Project Name: The Reserve at Pearl River

Subject: **The Reserve at Pearl River Site Plan PB #22-06**
Prepreliminary/Preliminary/Final
Site Plan and SEQRA Review
Blue Hill Road, Pearl River
73.10/1/6; OP-PAC zoning district

**Town of Orangetown Planning Board Decision
February 23, 2022
Page 1 of 20**

**PB#22-06: The Reserve at Pearl River Site Plan Permit #50255
Preliminary Site Plan Approval Subject to Conditions**

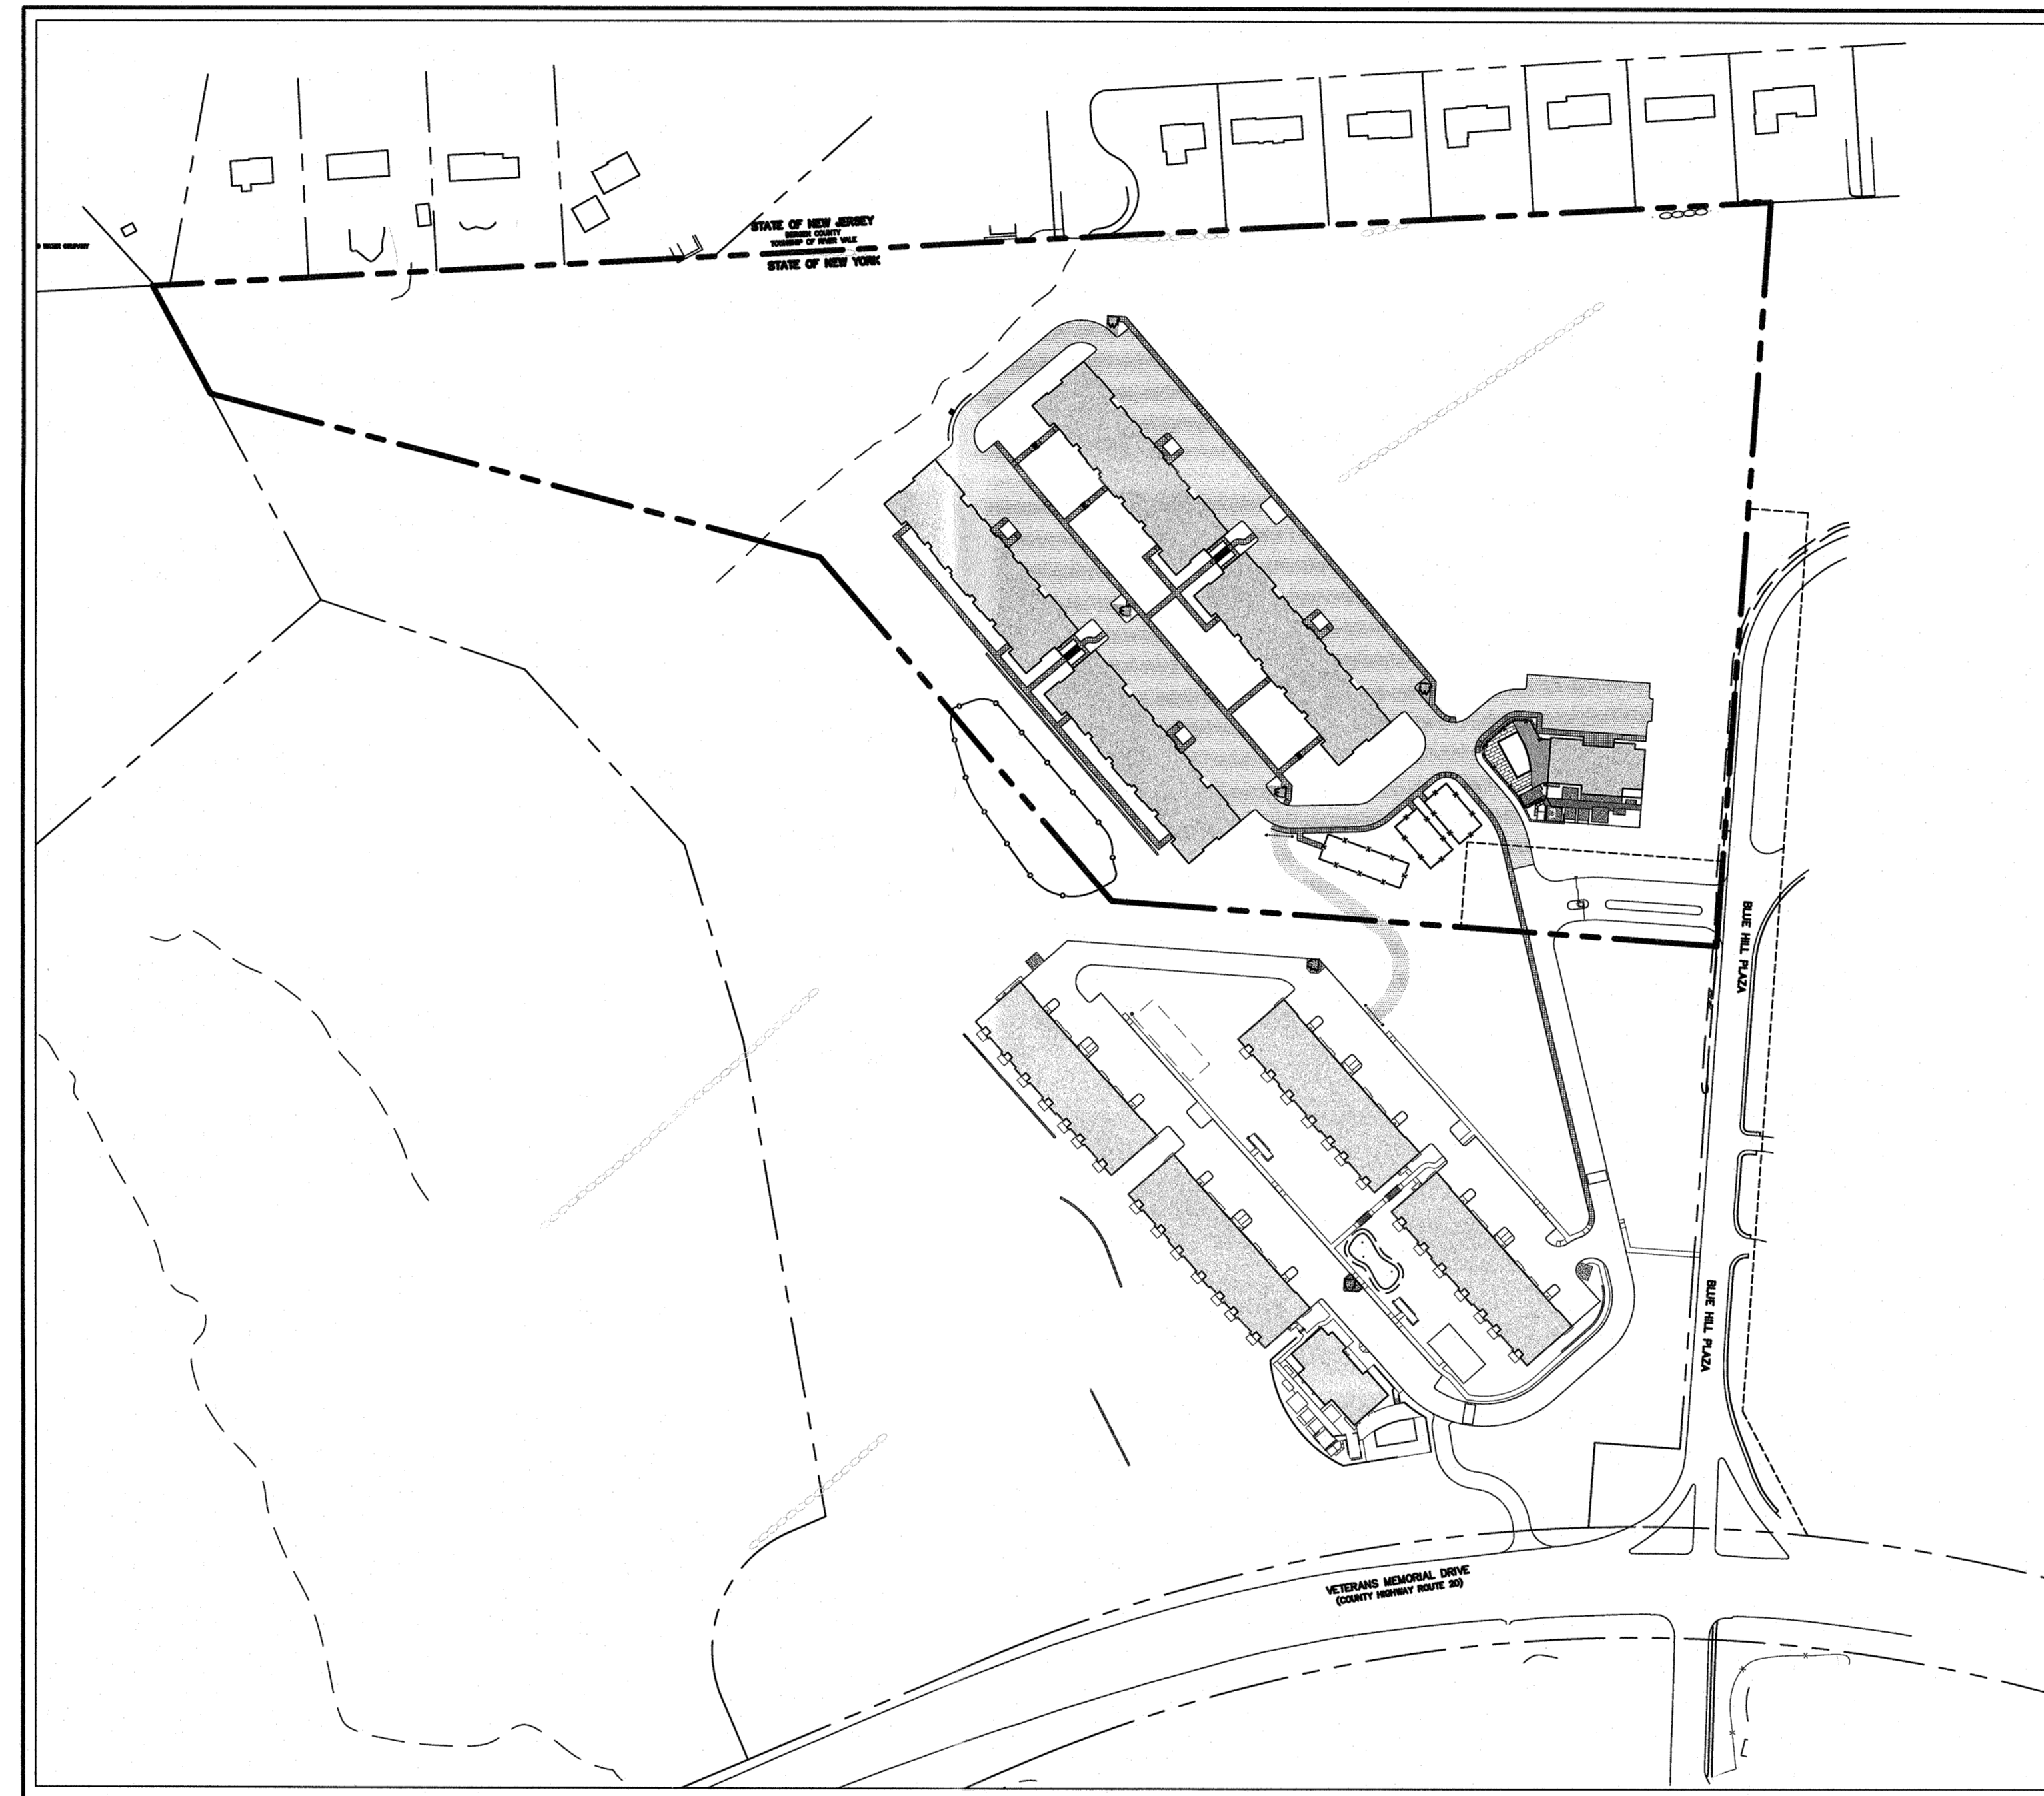
- The Vicinity & Zoning Map on Sheet C-000 of the site plan prepared by JMC, appears to have been misprinted, with a portion of the map located outside the box, and the highlighted site located south of the New Jersey border. This error shall be corrected.

- The Bulk Table on Sheet C-000 must be amended to state that 14 single units and 96 double units are proposed.

A-01
ARCHITECTURAL SITE PLAN
DATE: 11/22/2021

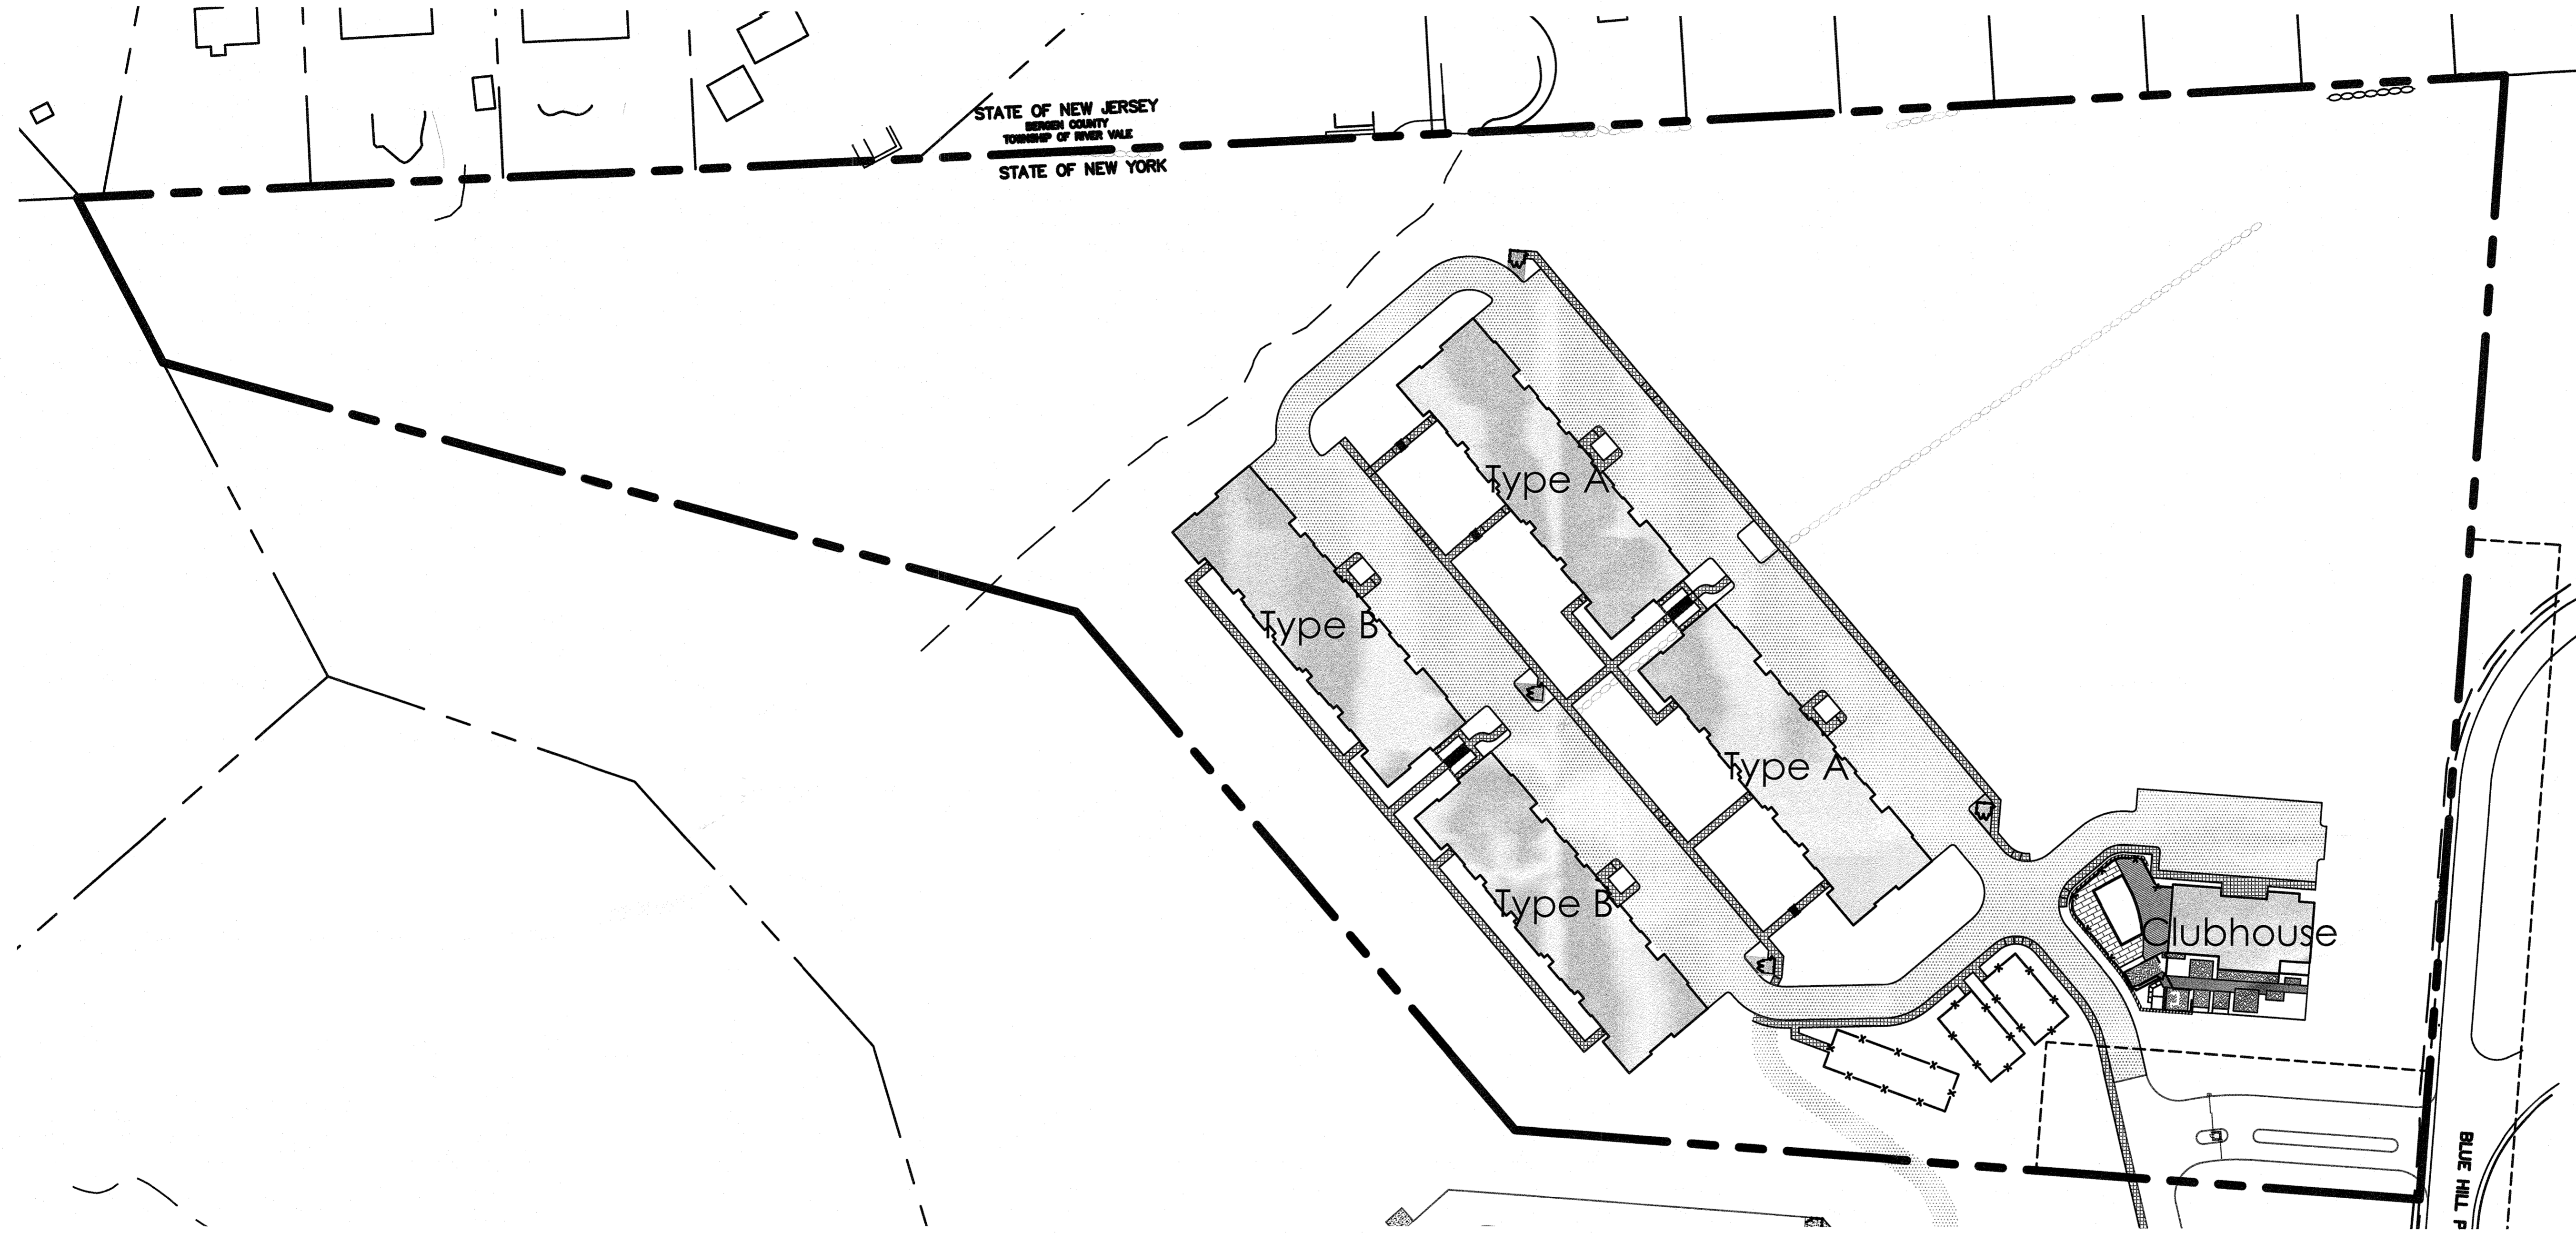
- The Site Plan must include standard notes, including district information.
- The location map on sheets C-01 and A-01 of the architectural plans, prepared by Minno & Wasko Architects and Planners, must contain a north arrow, especially since north is not oriented to the top of the page.
- In the Project Data on Sheet C-01, the building height is listed as ~ Stories 00'-0". The number of stories and building height shall be added.
